Re: Review of Stormwater Management Plan at 150 Gundy Road, Scone

Northrop Consulting Engineers have been engaged by Upper Hunter Shire Council (UHSC) to review the Stormwater Management Plan prepared for the proposed development (DA163/2017) at 150 Gundy Road, Scone.

NORTHROP MARKUP
23/12/2021
NL213311

Drawing Title
PROPOSED DEVELOPMENT LAYOUT

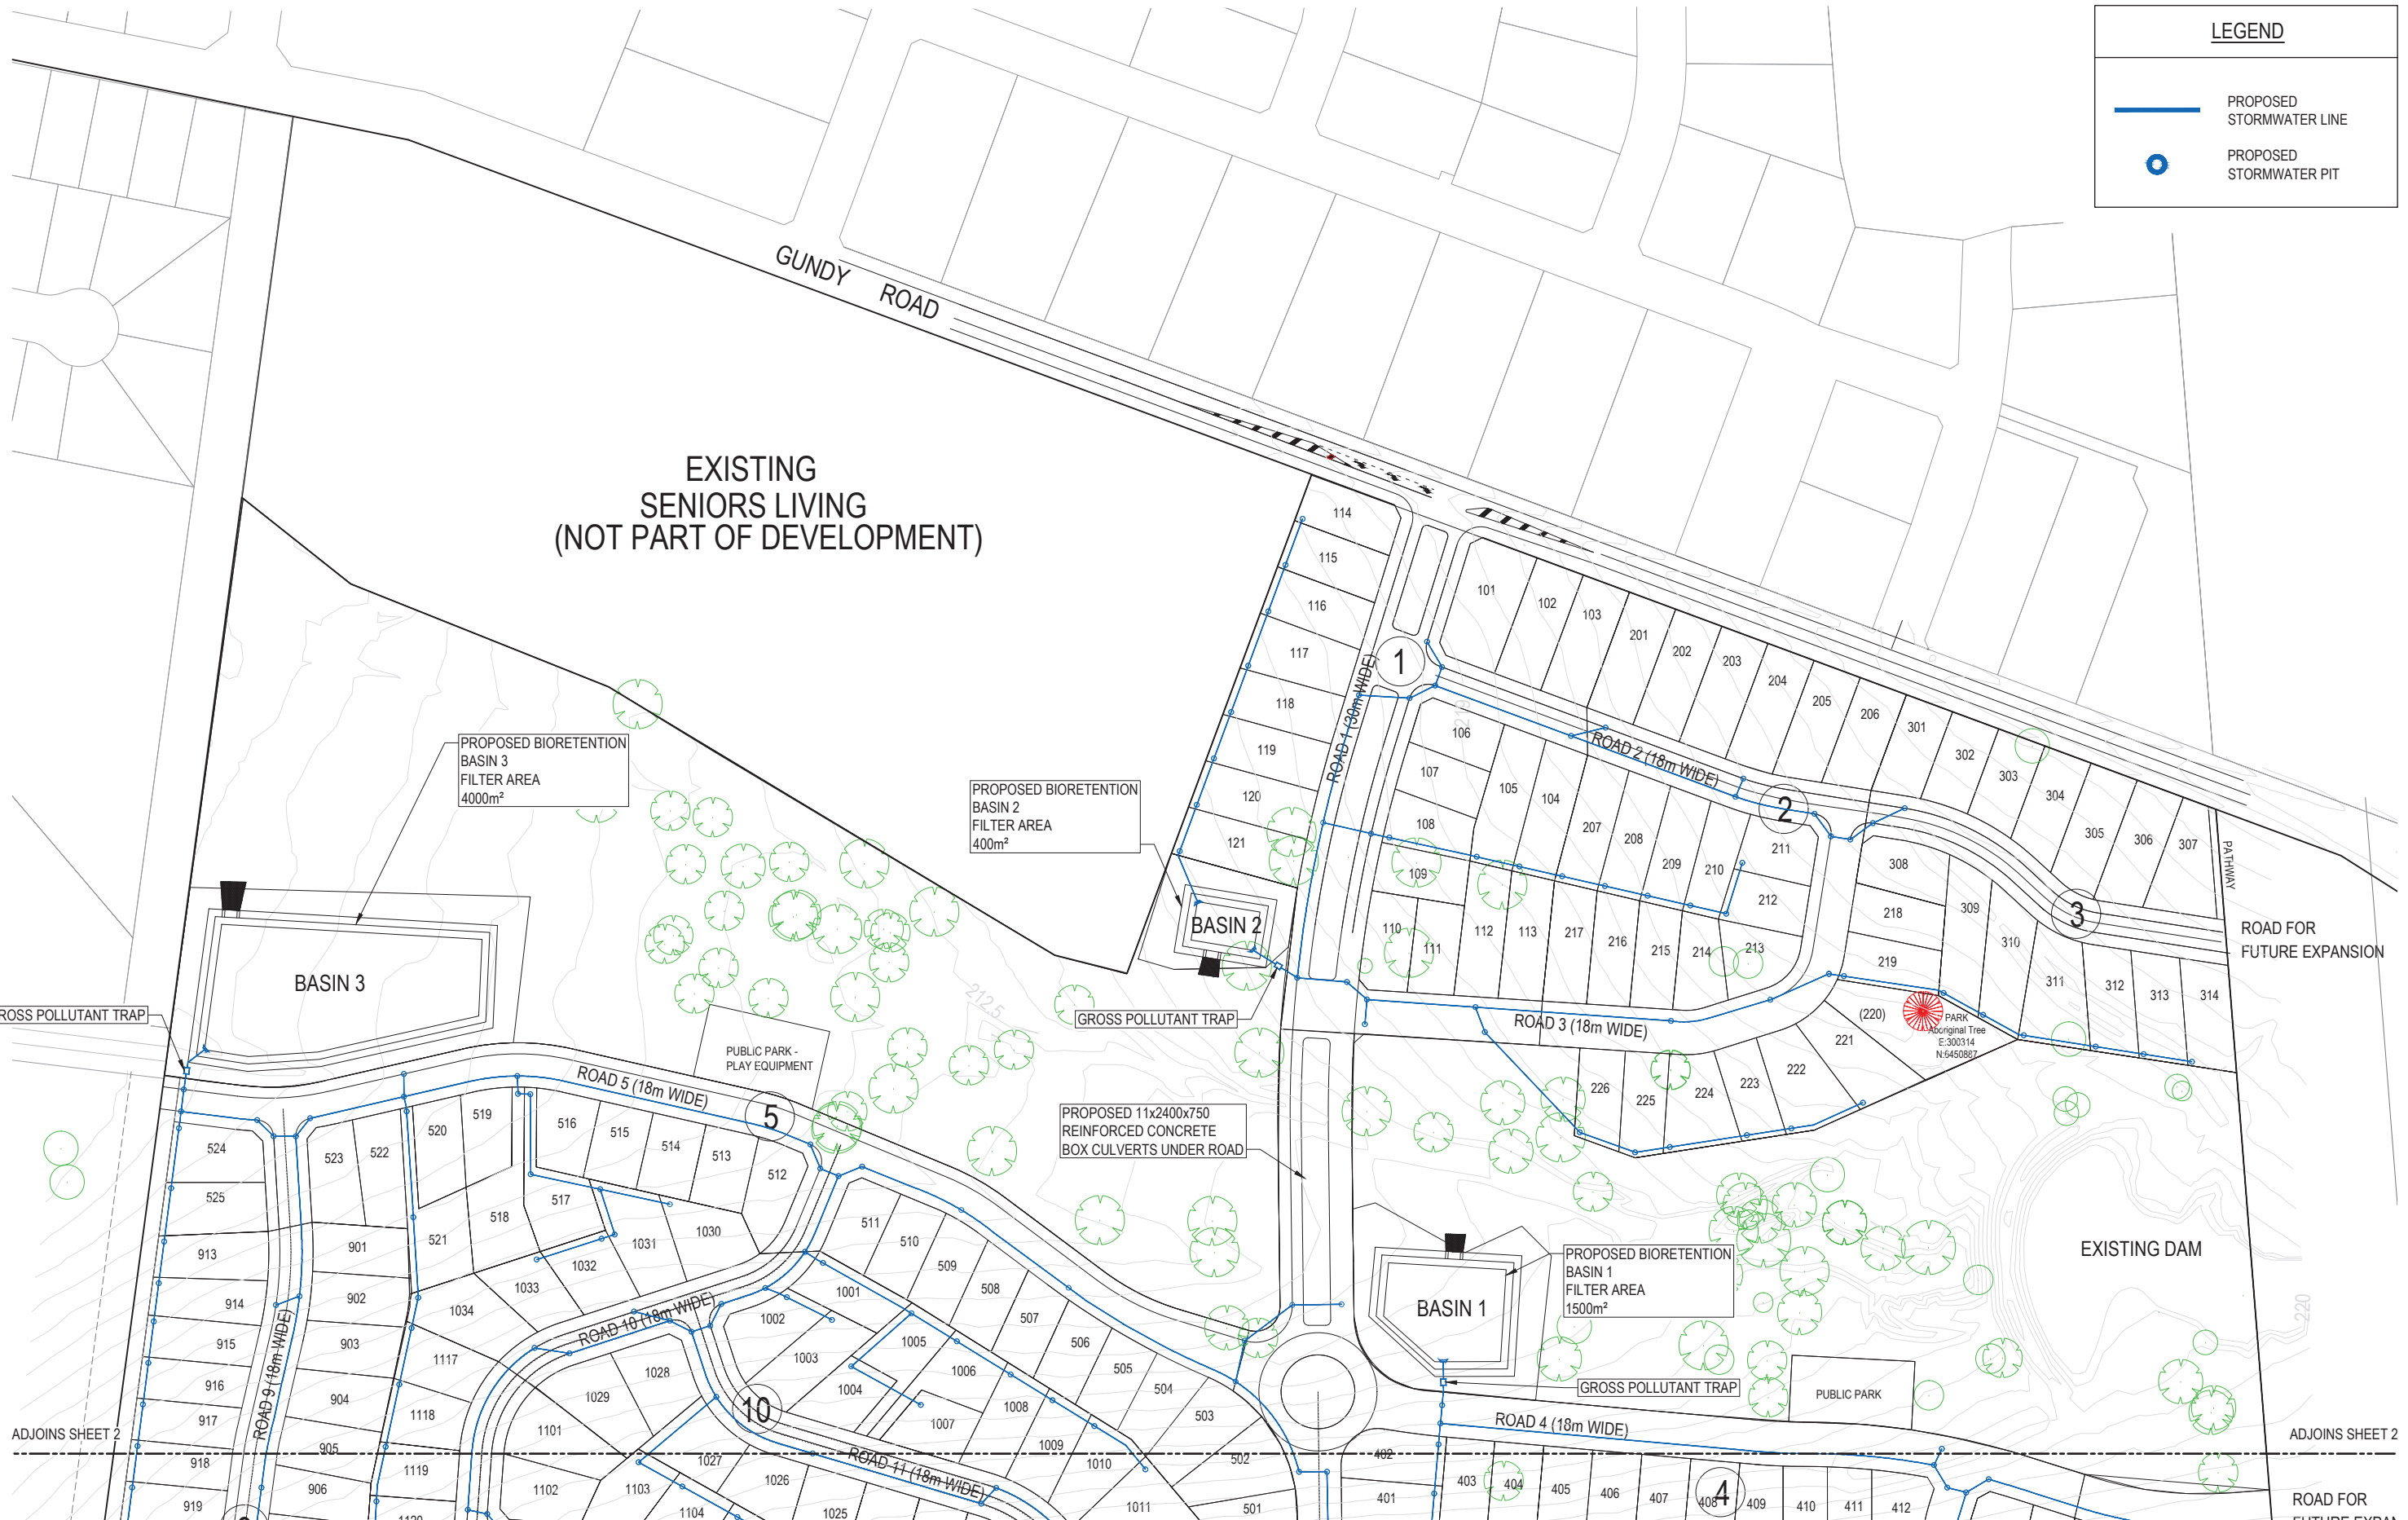
Are there flood level increases due to fill for roads / lots / basins? Potential for impacts to Seniors Living and downstream residential lots. Two-dimensional study recommended to confirm impacts.

Recommended to define the riparian extents so that the placement of the basins can be reviewed with respect to the NRAR Guidelines?

Does Gundy road have the capacity to convey the 1% AEP? If not, are the proposed lots susceptible to flooding?

Are these lots flood prone? Delineation of the Flood Planning Level will assist to understand flood immunity.

How often do these public open spaces flood?

Design of the Creek culvert crossing should consider evacuation and climate change.

What is the flood immunity of the emergency access track?

Do the basins comply with NRAR Guidelines for riparian corridors?

Is there a dam safety risk for downstream properties in the event of dam failure? Flood extents around the dam will need to be reviewed to ensure adjacent lots are flood free.

There are two site discharge points at this boundary with no formal drainage easement / watercourse connection. There may be a risk of excessive erosion and scour. Furthermore, given there are no water quality devices at the discharge points, does this still achieve the targets?
